**ADDENDUM NO: 3**

**IMPROVEMENTS to PAVILION LAKE PIERS,  
DOCKS and GANGWAYS**

**DATE: 4/6/2020**

#### Description: RFI Questions and Answers

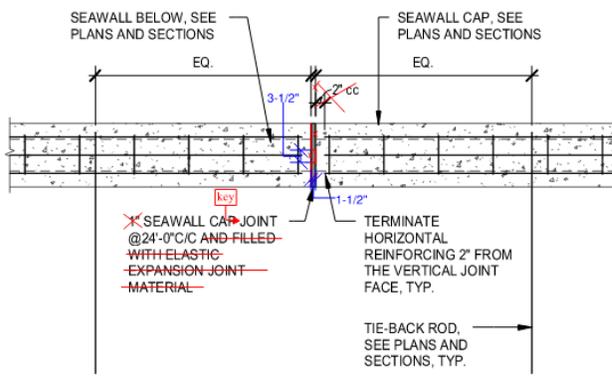
6. Plans Page S-2.00, Detail 1 – Is the 2 ft. x 2 ft. crushed stone sump around the weep holes continuous for the total length of wall or are those individual sumps at each drain location? If individual at each drain please specify their length along the wall

**MUE Response: this applies continuous along the complete length of the new seawall.**
7. Plans Page S-2.00, Detail 1 – What elevation or depth below the bottom of the concrete cap does the filter fabric extend to?

8. Plans Page S-2.00, Detail 1 – Does the filter fabric extend down the landside face of the sheet wall and then wrap around the crushed stone drain sump and then extend below the sump? Please clarify and provide dimensioning for the fabric.

**MUE Response: it extends 18" below the weep hole or 12" below the crushed stone.**

**MUE Response:** Yes it does. The filter fabric is continuous along the complete length of the wall and extends from 18" below the weep hole to the bottom of the cap.

**B** TYPICAL SEAWALL CAP JOINT DETAIL  
S-1.00 1/2" = 1'-0"

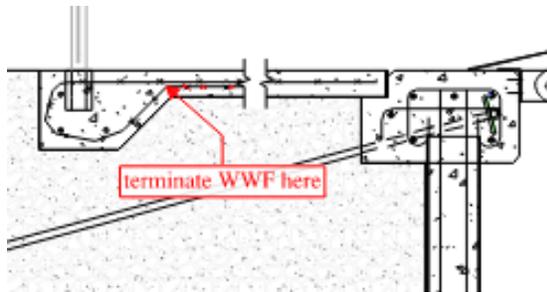
9. Plans Page S-0.00, Note 315000-3 - Please provide a detail of the keyed control joints that are required at a maximum spacing of 12 feet on center in concrete cap.

10. Plans Page S-0.00, Note 315000-3 – “Keyed control joint spacing of 12 ft on center (midway between anchor rods)” will not work as anchors are spaced at 8 ft on center. Please clarify.

11. Plans Page S-0.00, Note 315000-3 states 1-inch expansion joints are required at 48 ft. OC but Plans Page S-1.00, Detail B shows joints at 24 ft. OC. Which detail or note governs?

**MUE Response:** The keyed control joints shall be placed 24 ft (not 12 ft as mentioned in note 315000) on center and must be located centered between anchors. The keyed joint shall be a vertical keyed joint located at the center of the cap; The keyed joint shall be 3-1/2" wide and 1-1/2" deep. The cap longitudinal reinforcing must be terminated at each side of the keyed joint.

**MUE Response:** Please see our response to question 9 above.

**MUE Response:** The cap key joints at 24 ft only. No additional expansion joints are required.

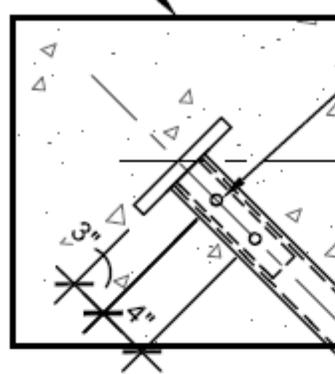
13. Plans Page S-2.00, Detail 4 – Appears that the WWF reinforcing is wrapping around 180 degrees through the thickened edge and the returning into the primary 4" sidewalk for some unknown distance. Please confirm our understanding is correct and specify the return length required.

14. Plans Page S-2.00, Detail 4 – Would the engineer allow WWF reinforcing mats to be two discontinuous horizontal pieces and not wrap vertically at the thickened edge?

**MUE Response:** That is correct. The bottom return of the WWF must only extend back to the 4" SOG section but does not have to be continued further; See snapshot below for additional clarification.

**MUE Response:** Yes, but the two mats must be spliced a minimum of 6”

HELICAL TIEBACK BRACKET (REF. TABLE 1)

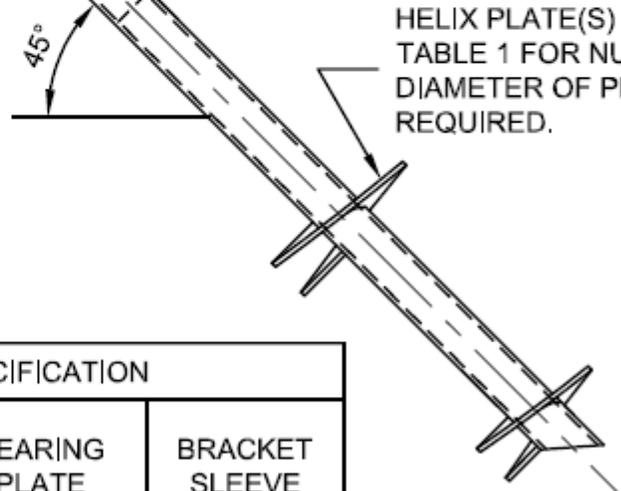
24. We have another question regarding the helicals that came from a subcontractor.

1. See attached detail. This would remove the all-thread from the scope of work. Could this be used in lieu of the currently called out pile components?

See Addendum No. 1 – refer to RFI numbers: 2, 19, 21, 22, 23 and 24. An alternate anchor detail such as the one suggested below is in general an acceptable alternate option but it most likely will require a larger cap and it will have to be modified to a 15 degree angle as per the current design.
